DCUSA Change Report		At what stage is this document in the process?
<h1>DCP 452:</h1> <h2>Correct application of Forward Cost Pricing EDCM charges to users connected directly to a Grid Supply Point</h2> <p>Date Raised: 28 February 2025</p> <p>Proposer Name: Andrew Enzor</p> <p>Company Name: Field Gaia Ltd</p> <p>Party Category: CVA Registrant</p>	01 – Change Proposal	
	02 – Consultation	
	03 – Change Report	
	04 – Change Declaration	
<p>Purpose of Change Proposal:</p> <p>To correct an oversight in DCUSA which results in customers connecting directly to Grid Supply Point incorrectly facing a locational FCP charge relating to assets downstream of their connection.</p>		
<div></div>	<p>This document is issued in accordance with Clause 11.20 of the DCUSA, and details DCP 452 ‘Correct application of Forward Cost Pricing EDCM charges to users connected directly to a Grid Supply Point’.</p> <p>DCP 452 is considered to be a Part 1 Matter and therefore requires Authority approval prior to being implemented and thus, the result of the Party vote on this Change Report will act as a recommendation to the Authority.</p> <p>Parties are invited to consider the proposed amendment (Attachment 1) an

Figure 2: FCP Grouping with a GSP-connected Connectee at a non-interconnected GSP

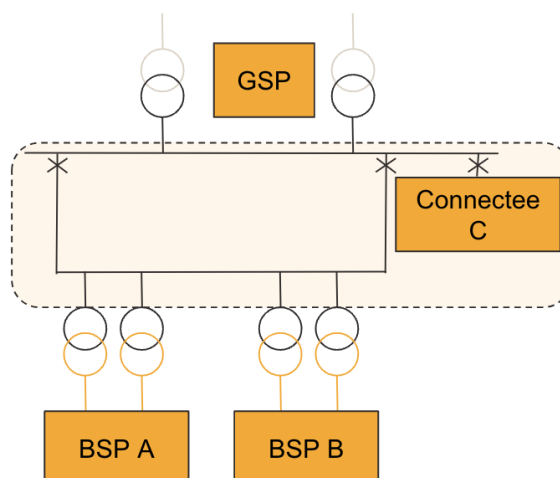
- 3.11 Figure 2 shows the same small section of network, with the addition of Connectee C. Connectee C's PoCC is at the GSP, so this Connectee would be assigned Customer Category 0000.

- 3.12 Under the FCP approach, Connectee C is included within the 132kV Network Group. The FCP (and LRIC) approaches both only consider thermal reinforcement. In the example shown, Connectee C cannot drive thermal reinforcement on the 132kV circuits to which the FCP charge relates. But it is (non-cost-reflectively) exposed to the locational charge/credit for the whole Network Group. Further, the capacity of Connectee C will be added to the denominator of the calculation of the FCP charge, so it will artificially reduce the FCP charge for the Network Group (on a £/kW basis), distorting charges for all other customers connecting within the Network Group.

- 3.13 Connectee C is facing a forward-looking locational charge/credit in respect of thermal reinforcement which it cannot impact.
- 3.14 Conversely under the LRIC approach, incremental demand at Connectee C's location is assessed for its impact on network assets. It does not impact powerflow on any of the 132kV circuits, so it correctly sees no locational charge/credit.

Figure 3: FCP Grouping with a GSP-connected Connectee at an interconnected GSP

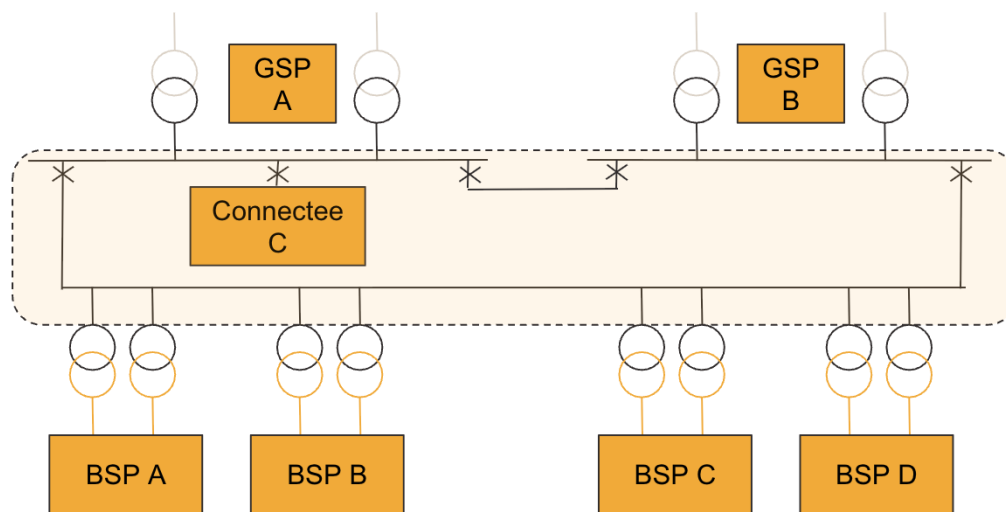
- 3.15 Figure 3 shows a similar section of network, but with interconnection between two GSPs. In this instance, the two GSPs are considered as a combined Network Group in the FCP method, and would be modelled as a combined network in the LRIC method.

- 3.16 In this example, Connectee C despite being connected directly at GSP A, can take power via 132kV circuits from GSP B under normal running arrangements, and so could drive thermal reinforcement on any of those 132kV circuits. In the LRIC variant of the EDCM, the impact of incremental powerflow at Connectee C's location would be assessed, which could include an impact on the 132kV circuits, in which case it could see a non-zero LRIC Charge 1. In the FCP variant, it is cost-reflective for it to face the full charge associated with the Network Group as its demand could be driving thermal reinforcement on any of the 132kV circuits.

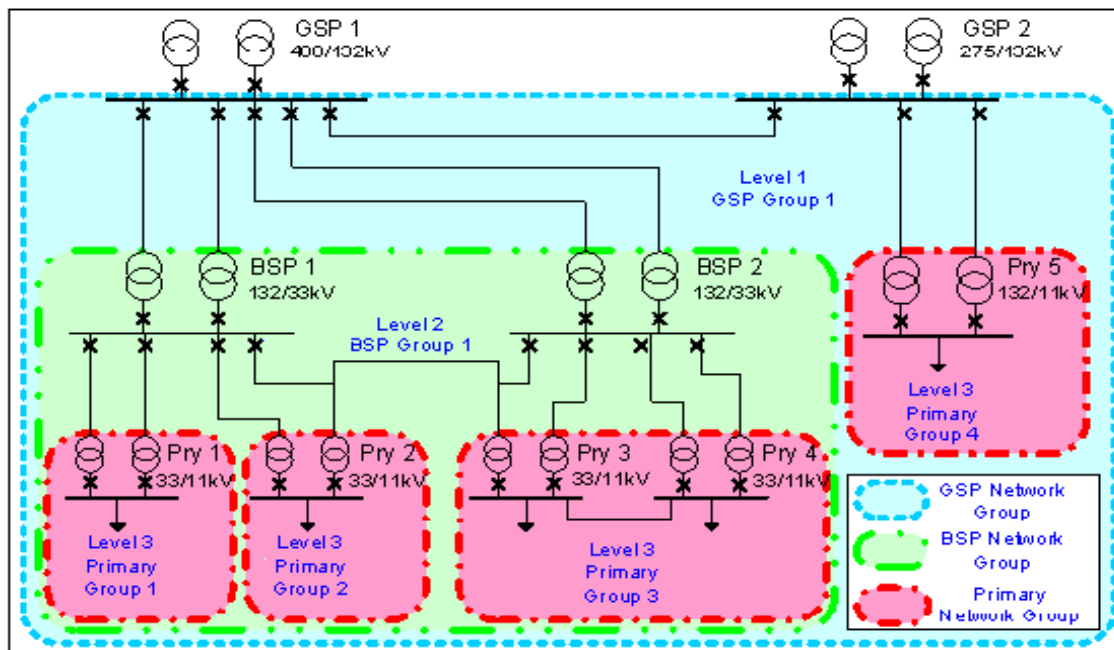
4.16 A counter view to what has been set out in the Change Proposal is that the methodology for calculating FCP charges for demand customers, as described in Annex 1 of Schedule 17 (Paragraph 6.5 and Figure 8 added below for ease of reference), defines the GSP busbar (on the distribution side) as part of the Level 1 Network Group.

4.17 It is interpreted that customers whose point of common coupling is at the GSP busbar (Category 0000) are thus within a Level 1 Network Group. Consequently, the FCP charges applicable to this Network Group should apply to these customers to maintain consistency with the established FCP EDCM methodology. Exempting Category 0000 customers from FCP locational charges could introduce inconsistency compared to other customers within the Level 1 Network Group and those in Level 2/3 Network Groups.

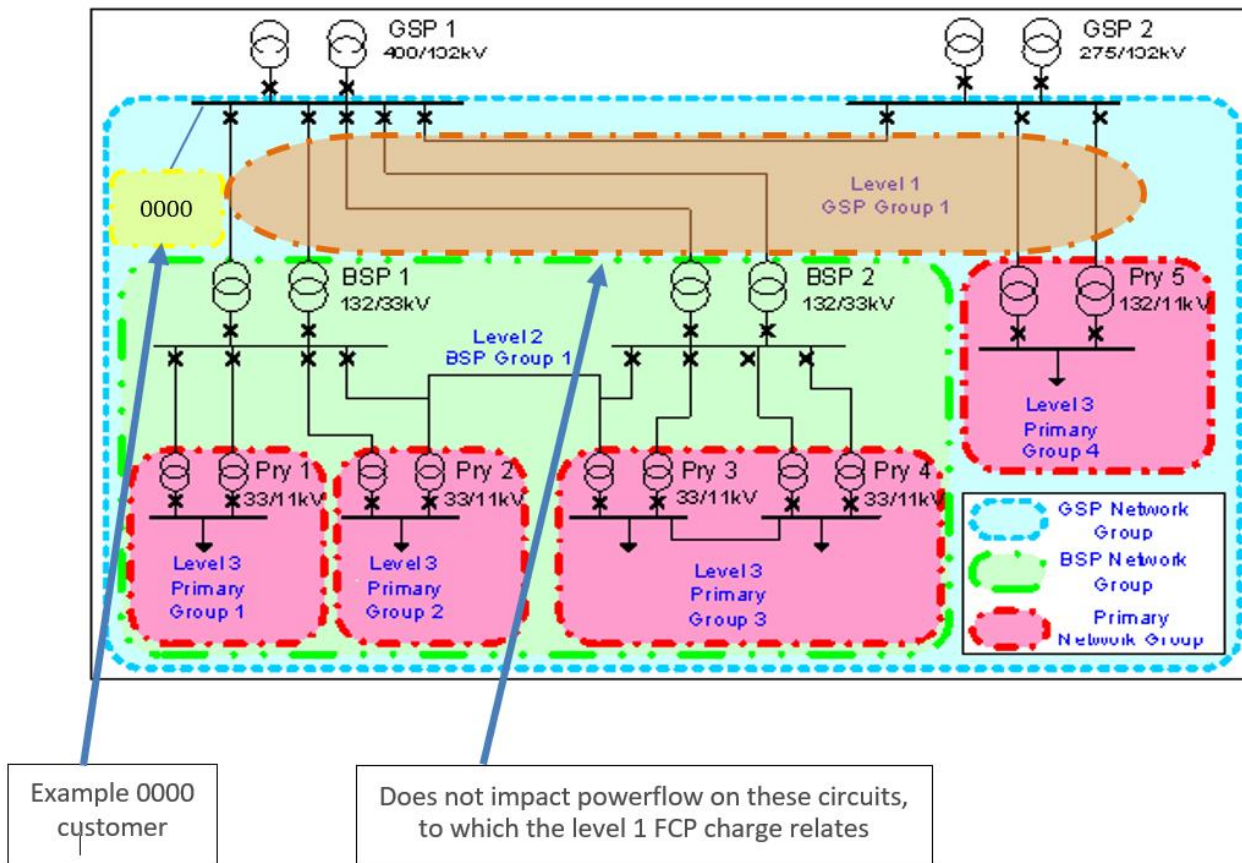
4.18 The Proposer suggests that while a 0000 customer may be within the Network Group, their connection does not drive reinforcement within that Network Group. Building on the example diagram, a new 0000 customer connecting within a Level 1 Network Group would not impact power flows on other Level 1 circuits. Therefore, it is considered inappropriate for such a customer to face forward-looking FCP charges related to those circuits.

4.19 The solution (as presented here, and updated from the original proposal form) explicitly excludes demand associated with 0000 customers at non-interconnected GSPs from the Level 1 Network Group. Paragraph 2.16 of Schedule 17 calculates the net present value of reinforcement within the Network Group and divides it by total capacity; hence removing demand associated with 0000 customers at non-interconnected GSPs will avoid the potential inconsistency identified.

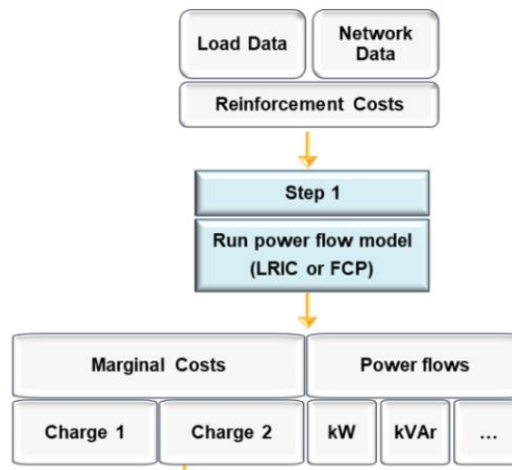
- 4.26 A counter view to what has been set out in the Change Proposal is that **Load Data** is a critical component in assessing future reinforcement costs for a Network Group (as shown in the Figure 1 of Schedule 17 – which provides a diagrammatic overview of the steps involved for import charges). Therefore, any demand growth contribution from connectees within a Network Group would contribute to the forecast of reinforcement costs for that group.

- 4.27 An example is where a 0000 customer with significant demand capacity, if exempted from the 'Charge 1 capacity charge' (meaning exempted from the reinforcement costs attributable to their large demand capacity), would unfairly expose other customers at same Level 1 and also downstream customers at Level 2 and Level 3, who have much smaller demand capacities, to the full reinforcement cost.
